NVT Motorcycles Limited

SERVICE SHEET NO. NVT - 8

SUBJECT: EASY RIDER MODEL ER2, STARTER CABLE ATTACHMENT

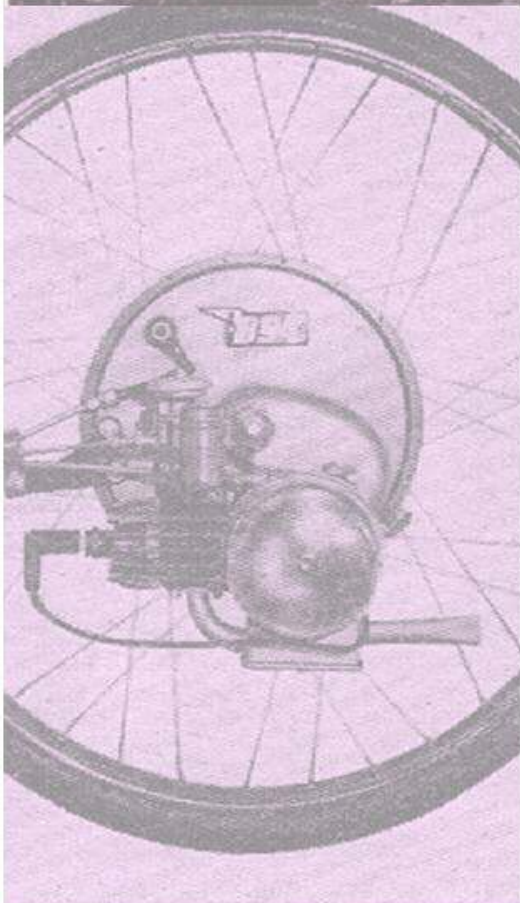
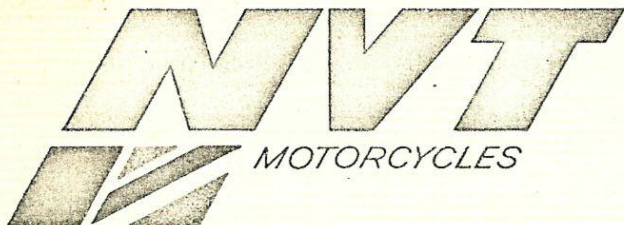
The latest version of the two speed engine, from engine number 2/1405 onwards, has a simplified method of connecting the lower end of the starting cable to the starting thrust ring assembly, located inside the right engine cover.

It is now possible to change the starting cable without removing the right engine cover which is the case with the original design.

The change introduces the following new parts, please make a note of the information in your copy of the Model ER2 Parts List publication number 09-0557.

Whilst the new parts can be fitted to earlier engines as a set, we intend to stock and supply parts of the original design to service engines prior to ENGINE NUMBER 2/1405.
